UNITED STATES
DEPARTMENT OF THE INTERIOR
BUREAU OF LAND MANAGEMENTOCD Artesia
NM OIL CONSERVATION
ARTESIA DISTRICTFORM APPROVED
OMB NO. 1004-0137
Expires: January 31, 2018**SUNDRY NOTICES AND REPORTS ON WELLS**
Do not use this form for proposals to drill or to re-enter an abandoned well. Use form 3160-3 (APD) for such proposals.

OXY USA WTP LP - Proposed
Government U #2
API No. 30-015-26402

OXY USA WTP LP - Current
Government U #2
API No. 30-015-26402

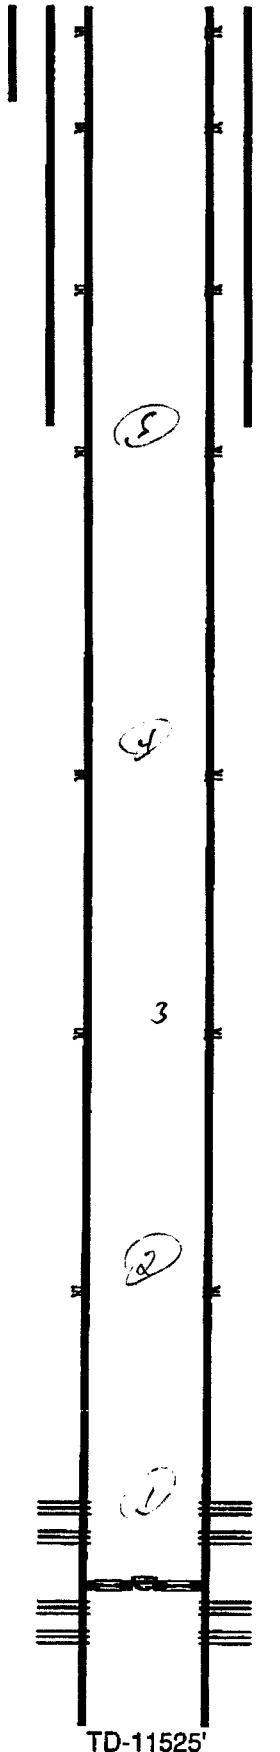
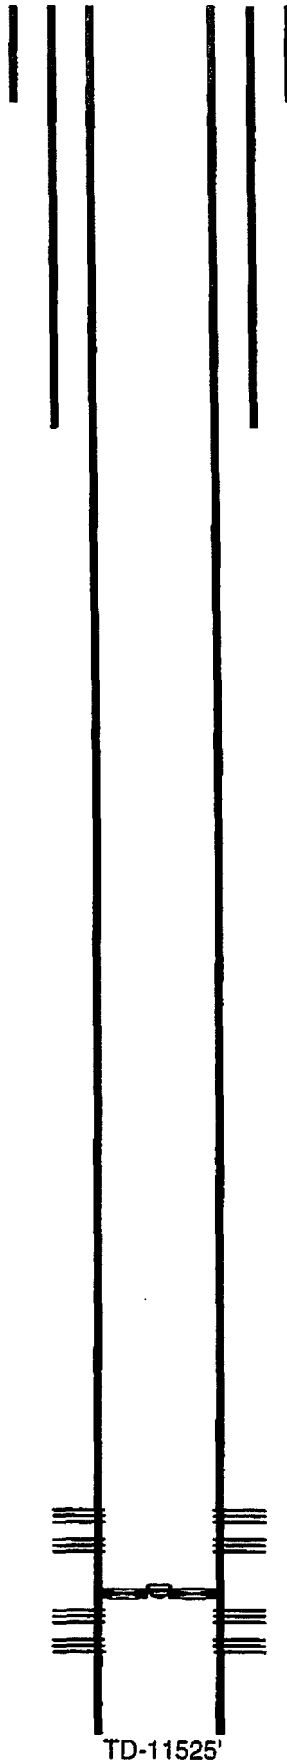
3078

50sx @ ³⁰⁷⁸3065-2935' WOC-Tag

Yates 750

⑤ Del 3028

④ BS 5241

Spiner ③ Dean 8410

② WL 8720

① AT 10438
